Alexandria City Hall

South Façade Colonial Revival Detail Restudy Recommendations

BAR Hearing 10/16/25

APPLICANT PROPOSAL: ALT 1 MODERNIZATION APPROACH

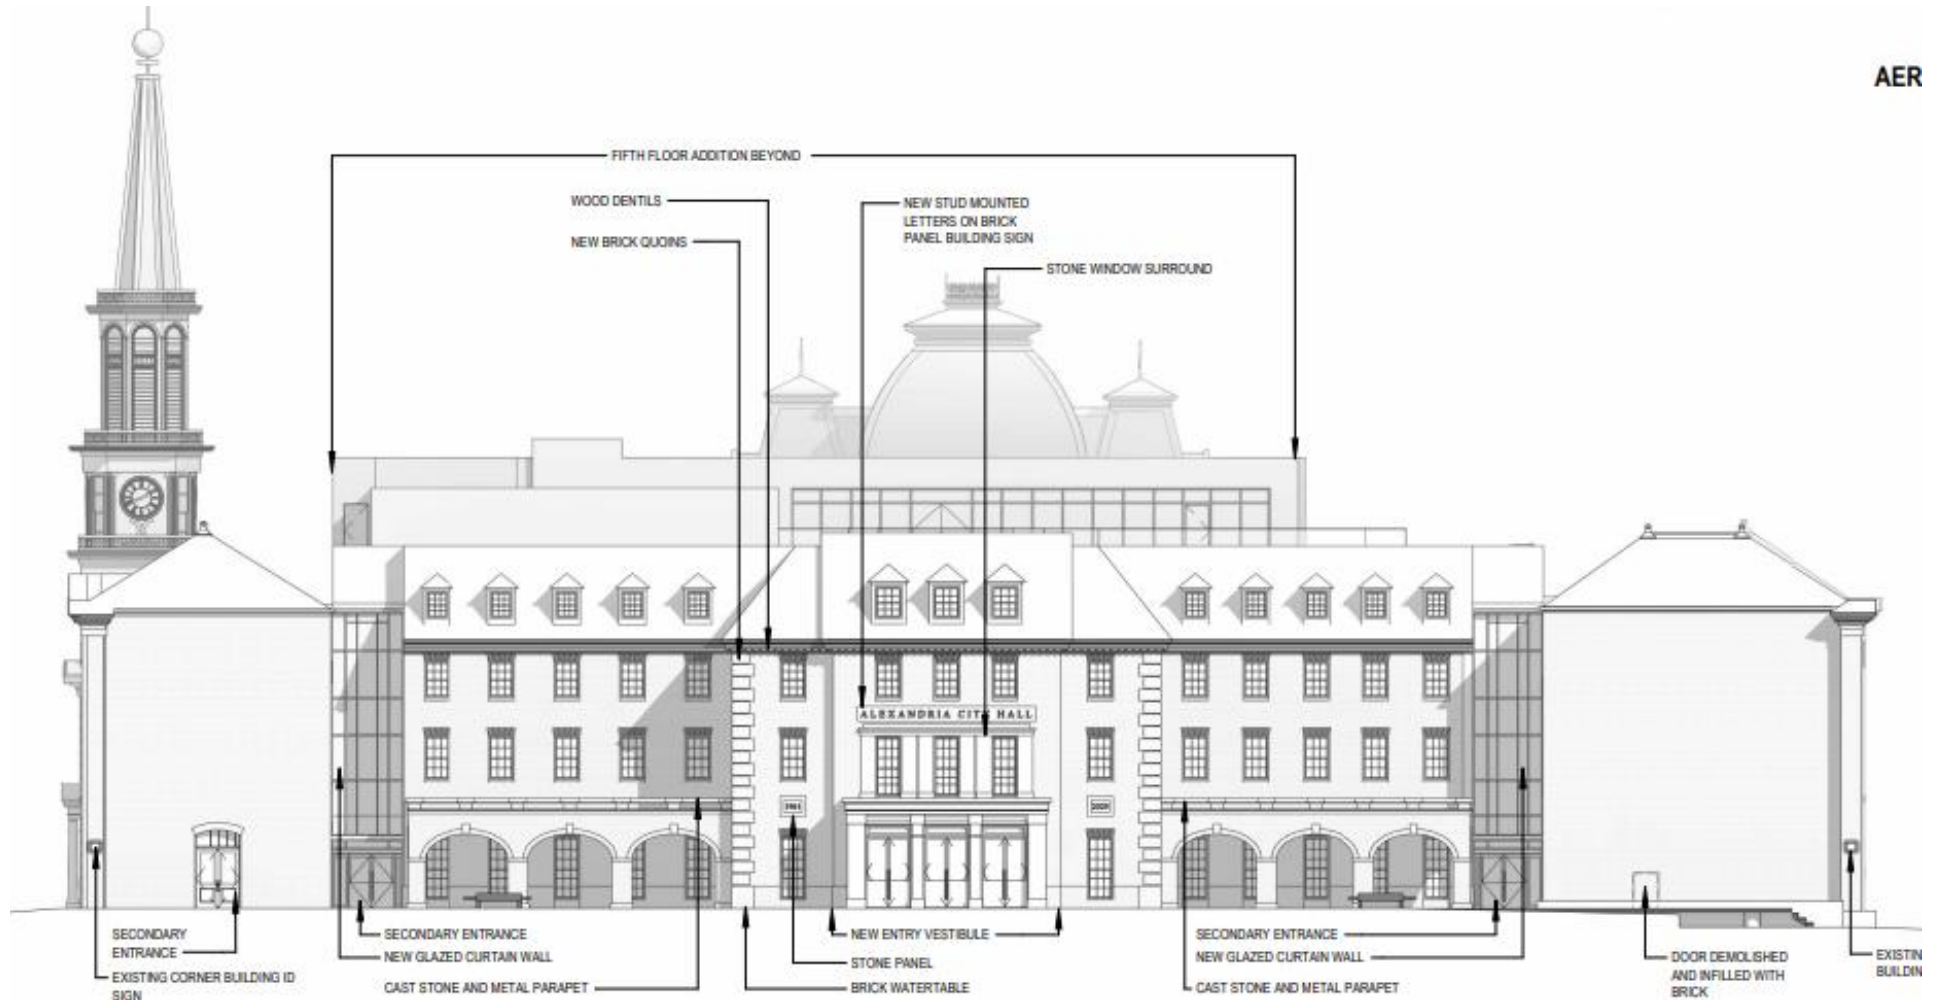
The raised roof above the new projecting entrance is inappropriate for a Georgian style building and creates unnecessary complexity in the traditional hip roof form. The new chimneys are in an awkward and untraditional location. The windows, and particularly the dormers, on the wings of the main block are visually crowded. The pilasters flanking the entry doors do not have classical proportions and appear to extend thru the entablature to the cornice. The quoins should have greater difference in widths, as shown on the Carlyle House and Christ Church. The new brick watertable cuts through the windows, which is not historically appropriate. The arcade makes absolutely no architectural sense on this facade. It will be expensive to construct and is shown with a “green” roof that will be difficult to maintain and visible to very few building occupants and the environmental benefits will be de minimis. While the vertical hyphens separating the 19th and 20th century portions of the building are welcome, why are they glass with a view of the fire stairs? This curtain wall should be something opaque that references other portions of the building, like slate or metal panels.

1. Remove the proposed shed roof form from the center of the hip roof and replace it with a flat roof and ornamental railing with plinths on the cornice above the projecting entrance feature.

2. Replace the two existing brick chimney forms in the appropriate scale, shape and location on the central hip roof.
3. Revise the detailing of the projecting entrance feature to be classically appropriate to the Colonial Revival style found in Alexandria. Refer to [Andrea Palladio's Four Books of Architecture](#) (Ware edition 1738); Sebastiano Serlio's [Five Books of Architecture](#) (English ed. 1611); or William Ware's [The American Vignola](#) (pub. 1903), etc. for the correct classical proportions and details of columns, entablatures, etc.

7. Remove the proposed non-functional flat roof arcades on the wings.
8. Make the glass wall of the exit stair hyphen an opaque material, like slate or metal panels, so that the illuminated fire egress stair behind is not visible from Market Square.

APPLICANT PROPOSAL: ALT 2 MODERNIZATION APPROACH

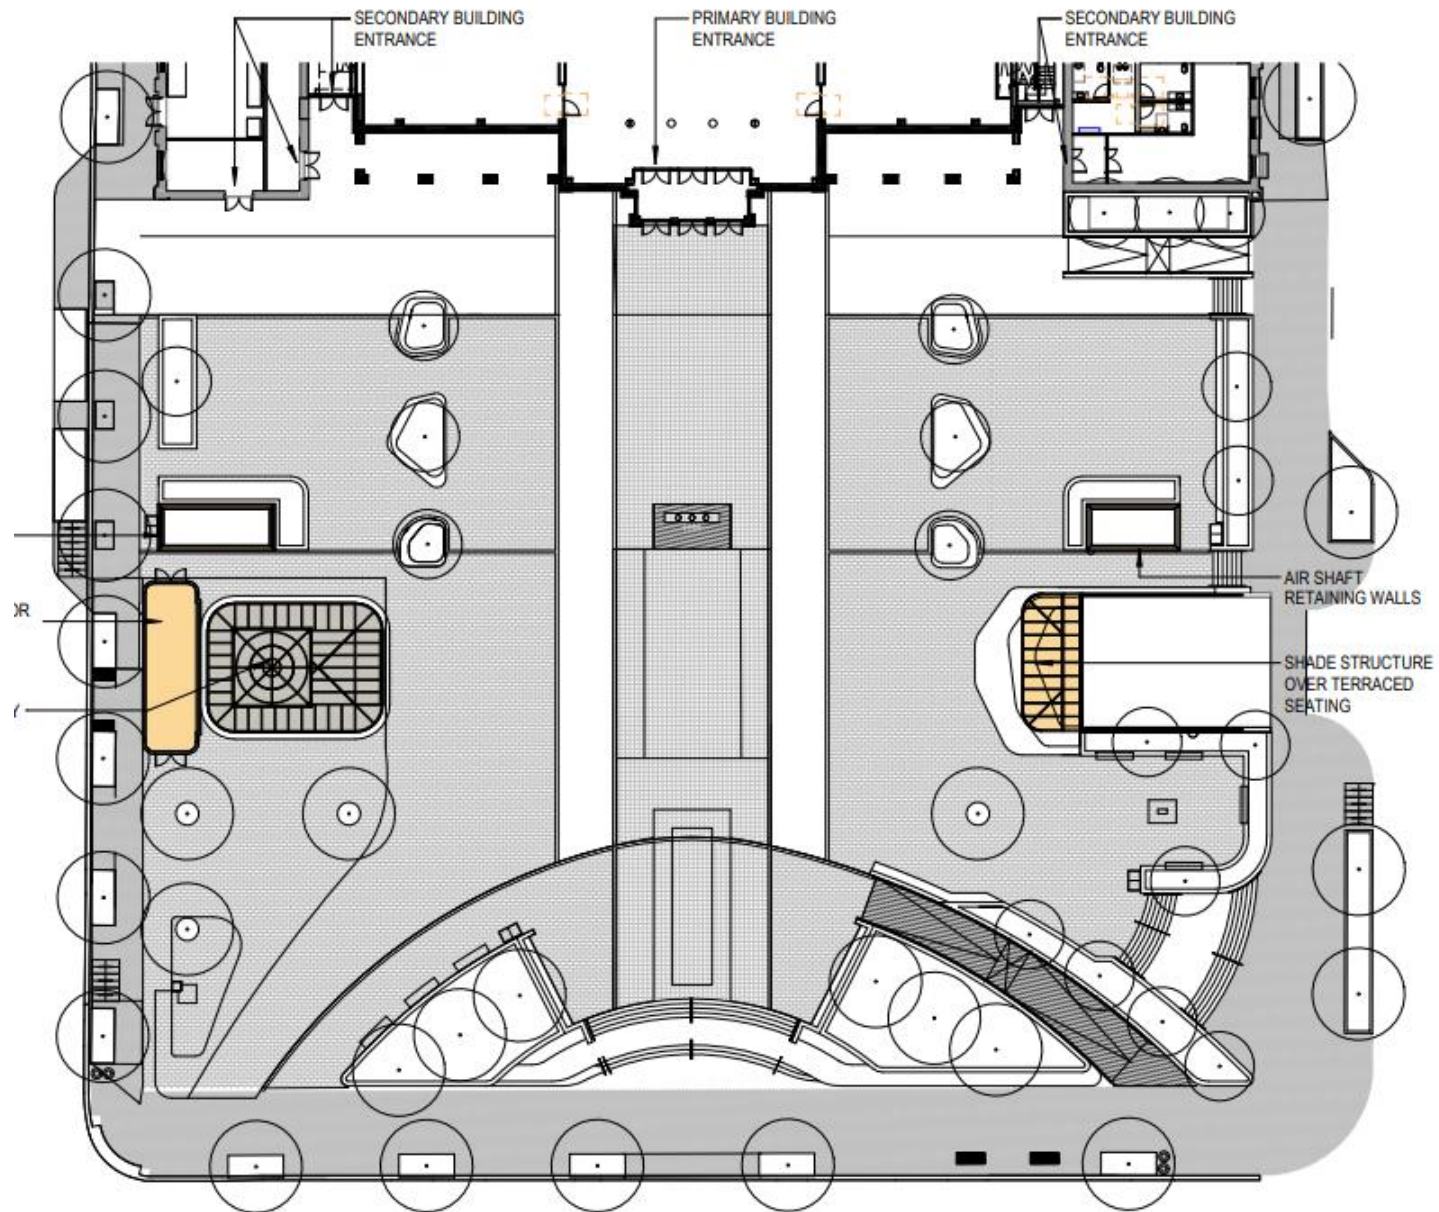
In addition to the comments in ALT 1, the pilasters of the second-floor stone surround do not have a capital or entablature and do not align with or relate to the first-floor entry vestibule.

The stone panels at the second-floor spandrel are characteristic of the later Adam or Federal style and inappropriate to the Georgian Revival style of this façade.

APPLICANT PROPOSAL: MARKET SQUARE

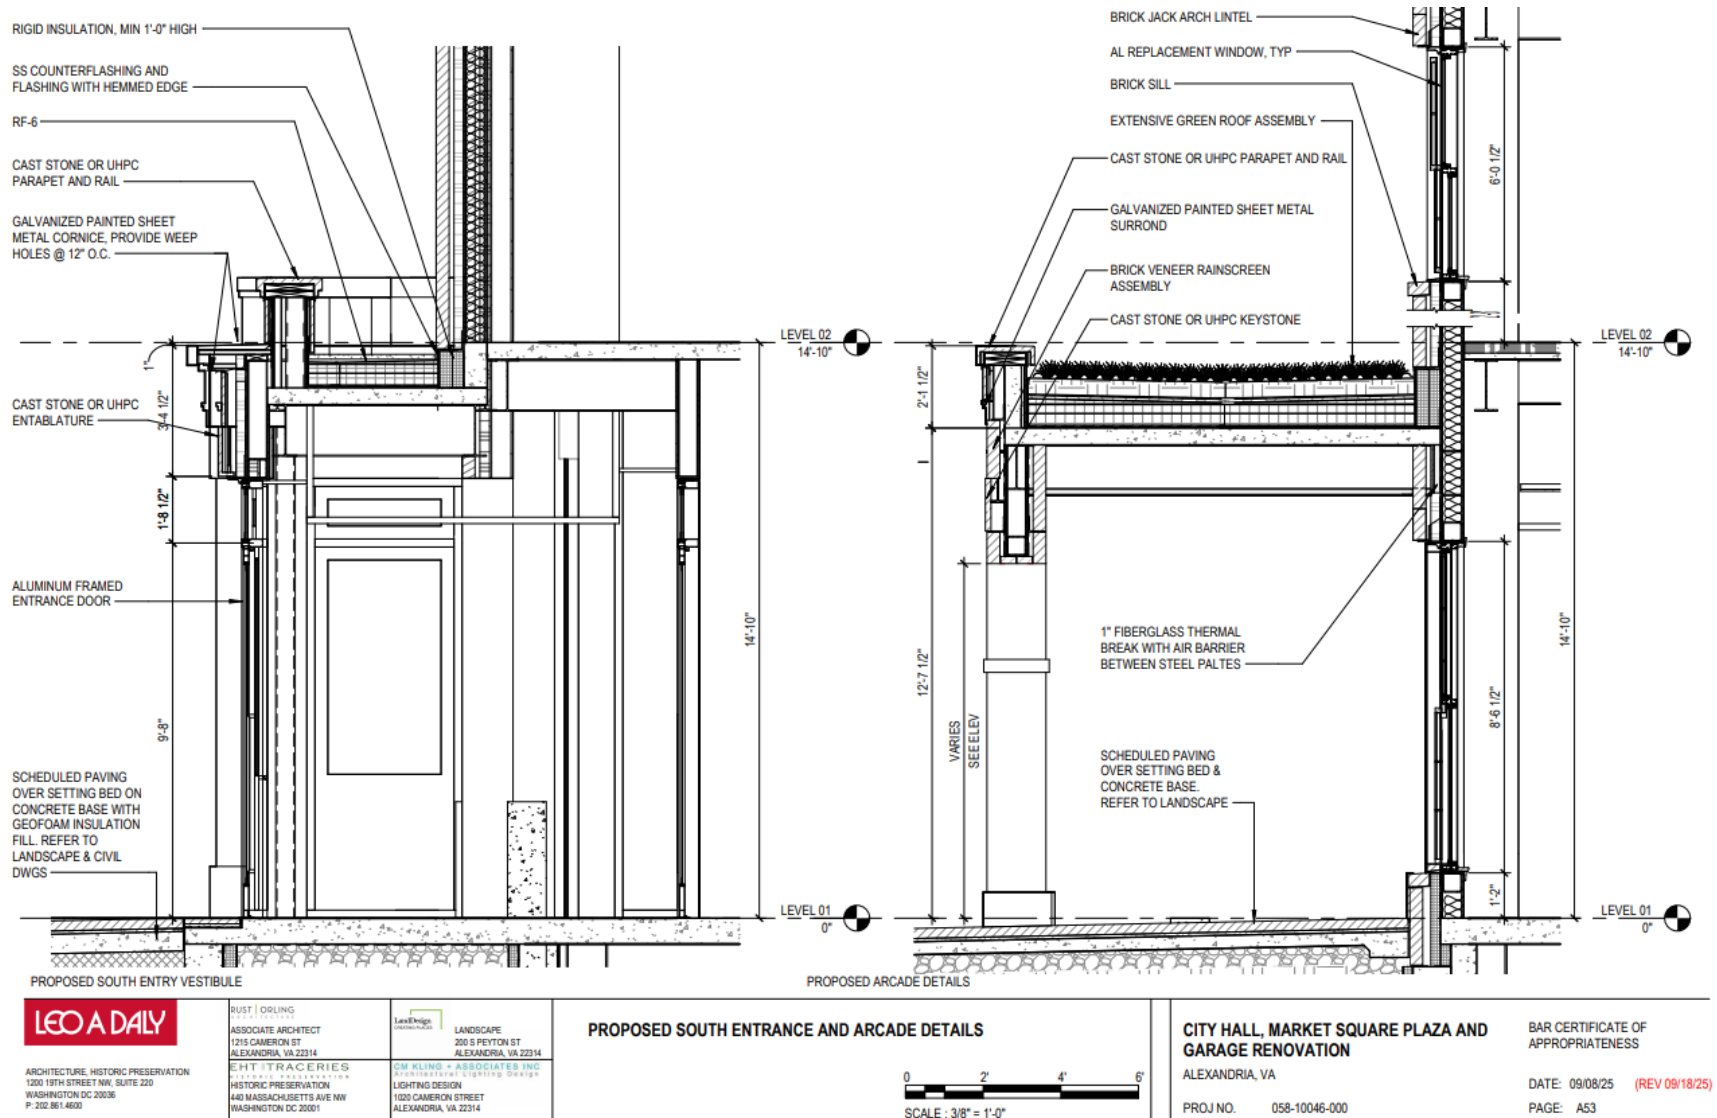
The irregular shape of the six new Mid-century Modern style planters and terraced seating platform are inappropriate to the formal and orthogonal Colonial Revival style of Alexandria.

9. Make the terraced seating platform and planters in Market Square orthogonal in a simple Georgian style.

APPLICANT PROPOSAL: ENTRY AND ARCADE SECTIONS

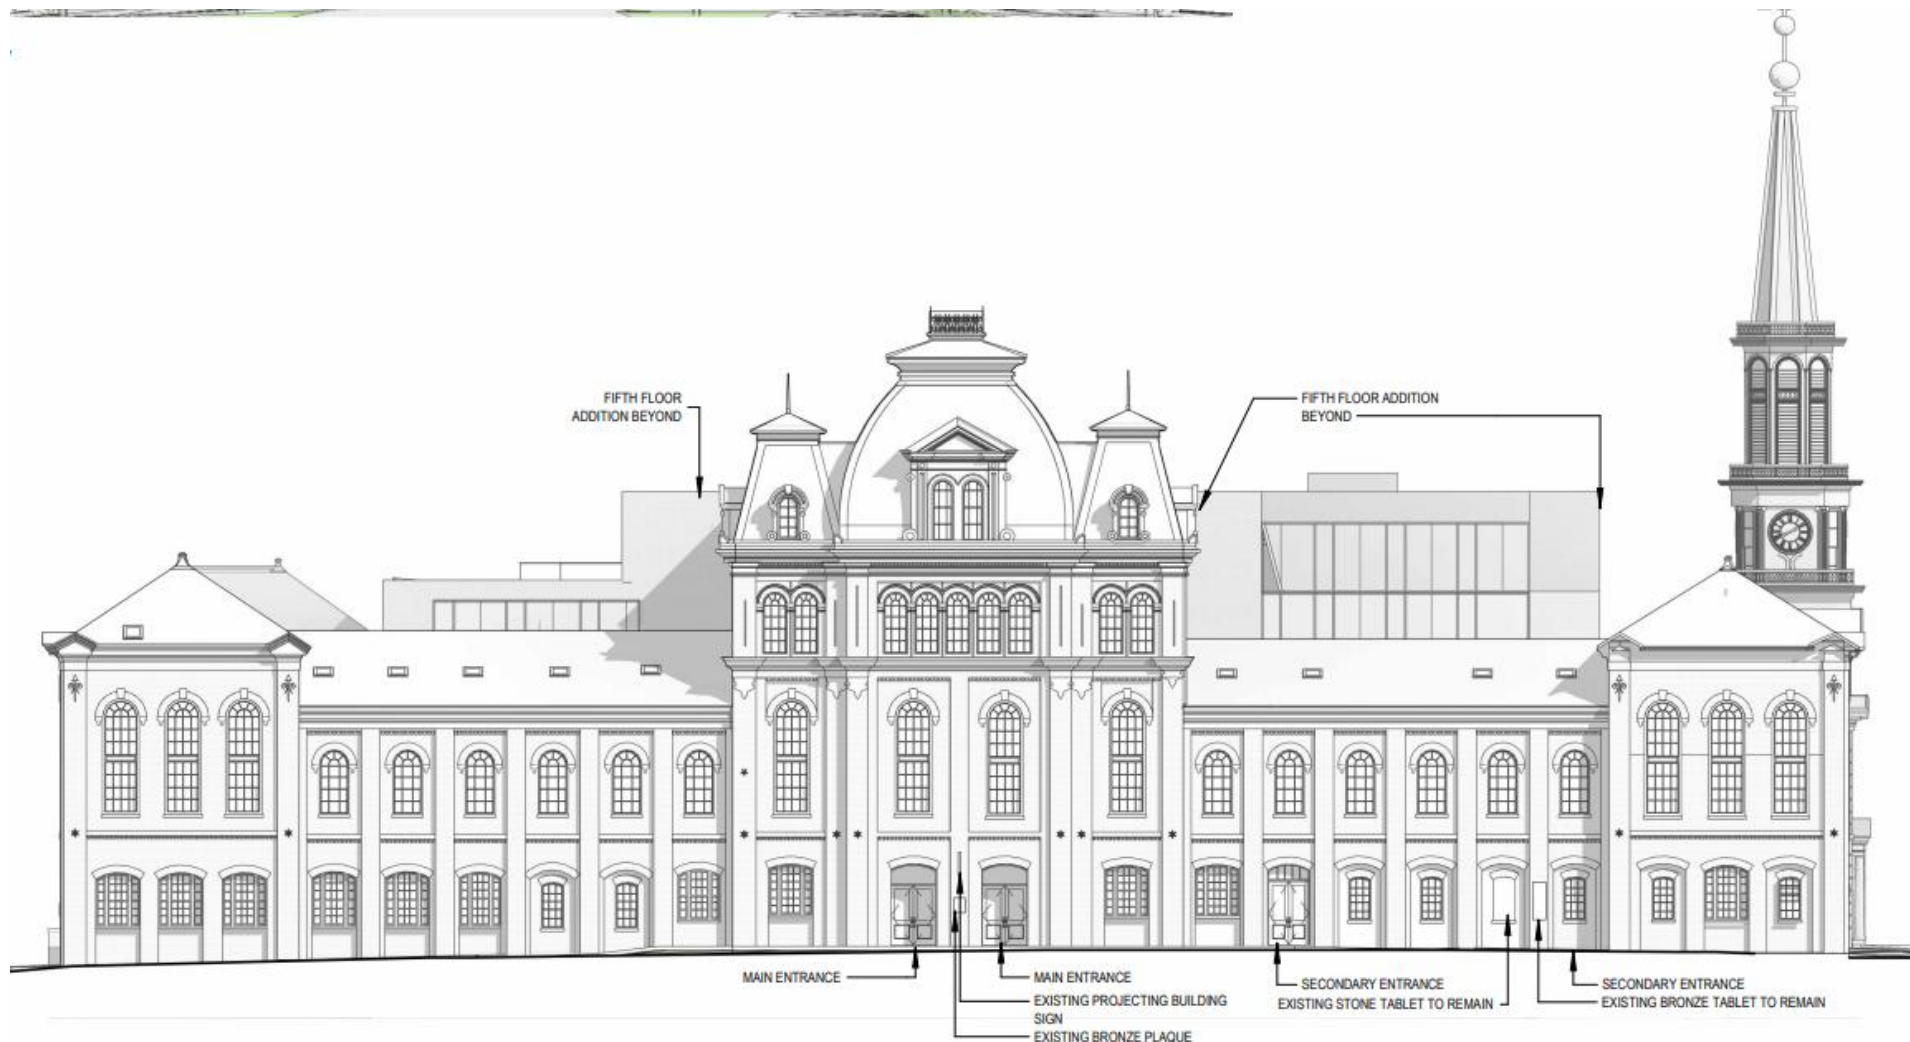
Pilasters at the building entrance extend inappropriately thru the entablature to the cornice and the pilaster base and capital are not correctly detailed.

The “balusters” above the entry are out of scale and lack appropriate detail.

The green roof of the pointless, reconstructed arcades will be expensive and difficult to maintain and are not visible to the public.

4. Study making the quoins, jack arches, entry pilasters, entablature and the balustrade of limestone or cast stone to give primary architectural prominence to the central building mass.

ALTERNATE SOUTH FAÇADE

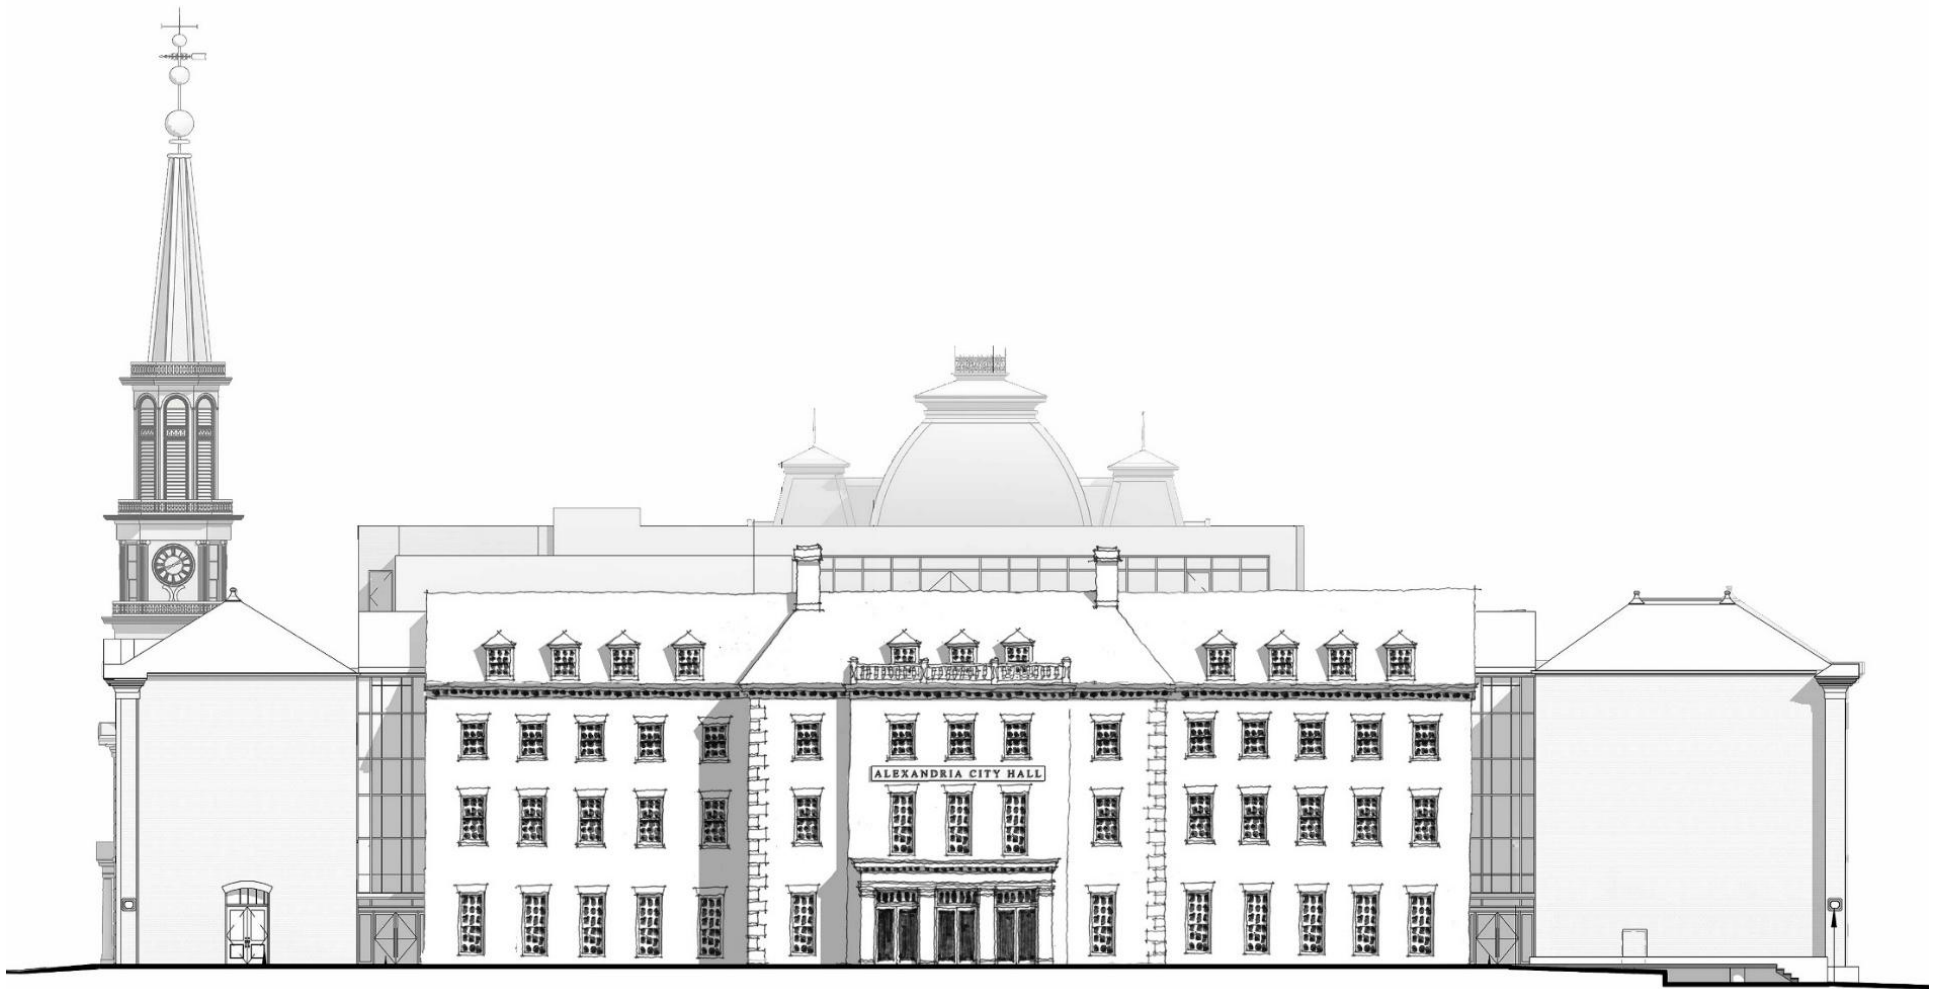
Recommended for Restudy

Strongly Recommended Revisions

5. Increase the differentiation in width between courses of the quoins to properly represent header and stretcher courses.
6. Delete the proposed brick watertable that intersects the first floor windows and delete the existing ogee brick projection at the second floor, as it conflicts with the proposed quoins.

1. Reduce the height of the windows as the height of the building increases.
2. Respace the windows on the flanking wings to provide more exposed brick and visual mass at the east/west corners of building.
3. Raise the roof of the main body of the building so that there is more room for a pronounced decorative cornice and more exposed brick between the lintels of the top windows and the cornice. Conversely, make the third floor windows slightly shorter.
4. Provide a continuous cornice with modillions or dentals appropriate to the Georgian style.
5. Rearrange the location of the dormers on the wings to align between the windows below to simplify the roof.
